OVERALL SITE PLAN  
SCALE: 1"=80'

**RECORD DRAWING**  
RECORD DRAWING INFORMATION IS PROVIDED BY PEASE & SONS, INC ON 05-04-2022. RECORD DRAWING INFORMATION WAS REVIEWED BY R. HAND OF SITTS & HILL ENGINEERS AND THE INSTALLATION SUBSTANTIALLY CONFORMS TO THE APPROVED PLANS. RECORD DRAWING CHANGES ARE ON THE CAD FILES SUBMITTED WITH THIS DOCUMENT.

**BCRA**  
PROJECT: FOR PUYALLUP SCHOOL DISTRICT  
**KESSLER CENTER**  
1501 39TH AVENUE SOUTHWEST  
PUYALLUP, WA 98373

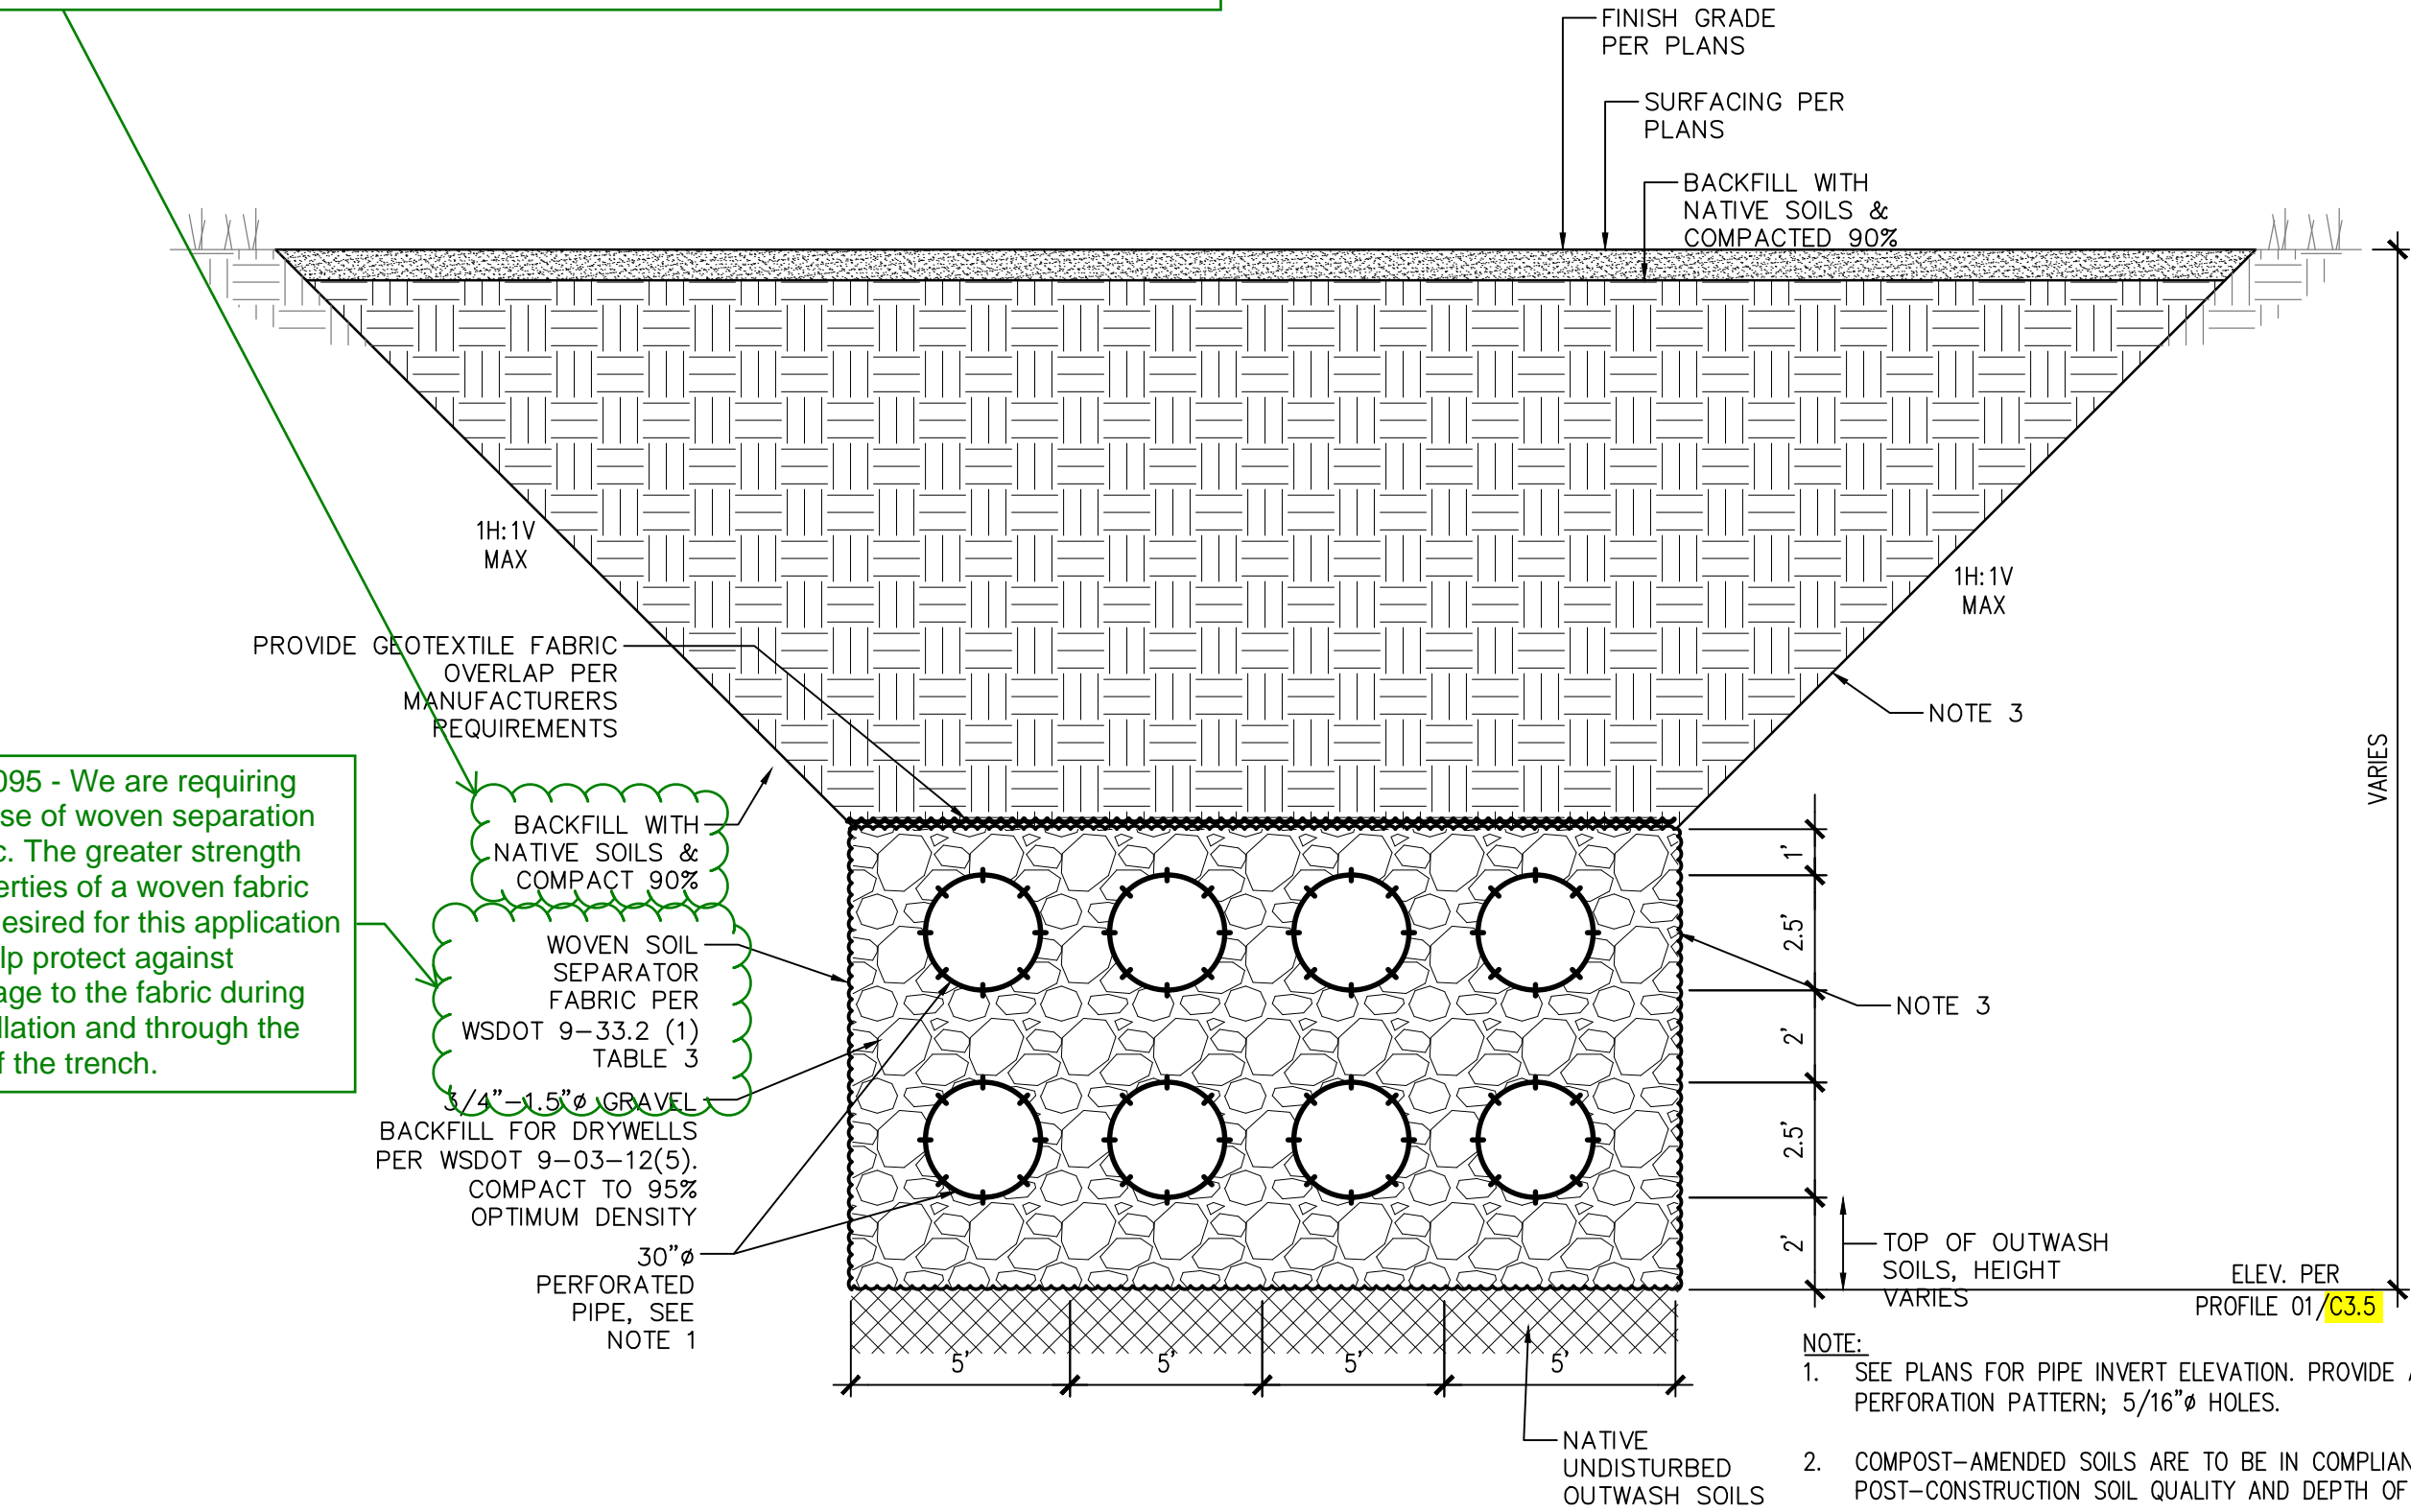
RFI-116 - 6" pipe size for roof drains and SDCO's is confirmed. Detail 2/C3.6 is in error and should indicate 6" PVC instead of 8" PVC.

**06 BIORETENTION SECTION**  
SCALE: N.T.S.

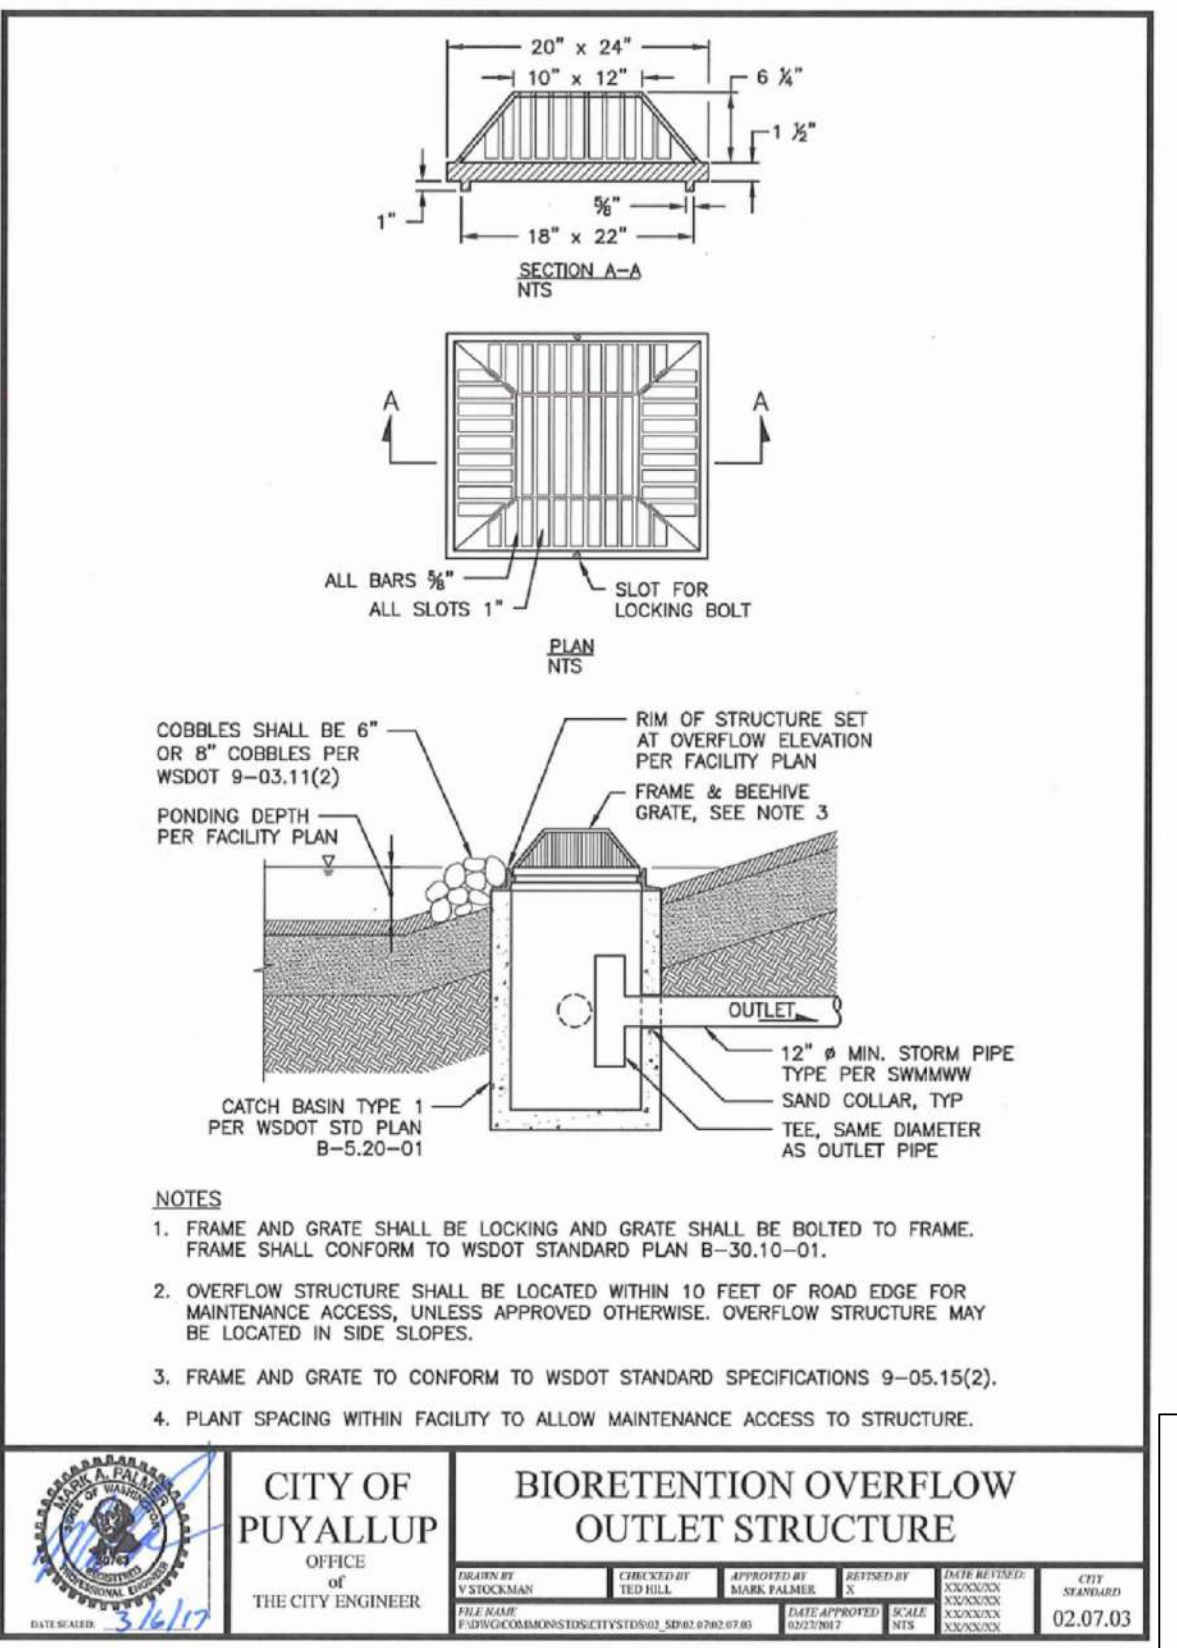
RFI-321 - BCRA takes no exception to proposed solution of conversion of bioretention area to pop-up spray heads around perimeter of pond. Delete the wood chip mulch from the bottom (wet area) of the bioretention pond.

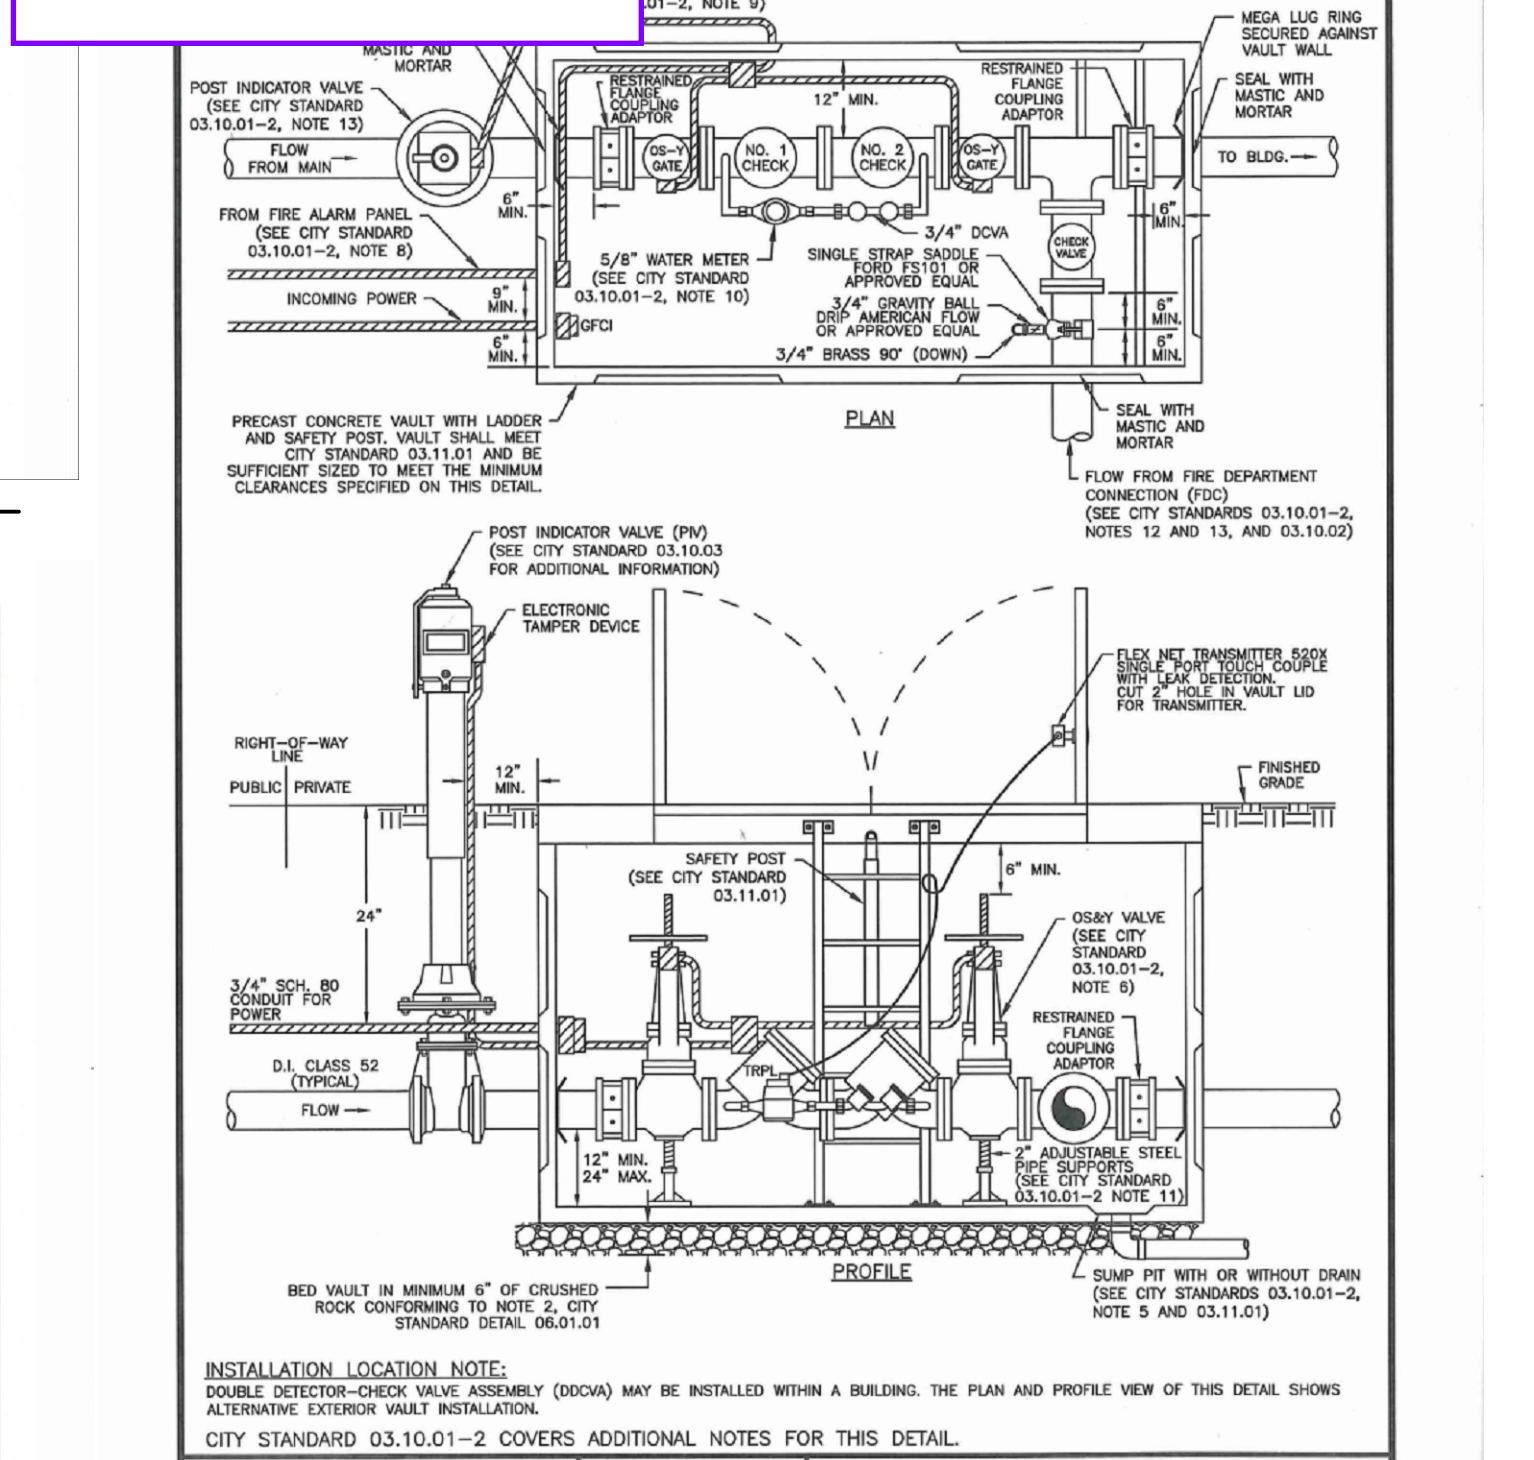
DELETED WATER MAIN, FH AND METER INSTALLATION LOCATED WITHIN THE WATER EASEMENT FROM CONTRACT WORK. WATER SYSTEM MATERIALS AND INSTALLATION BY FRUITLAND WATER AND/OR THEIR FIRE CONTRACTOR. WATER AND FIRE SERVICES BETWEEN THE METER AND BUILDING BY DISTRICT CONTRACTOR.
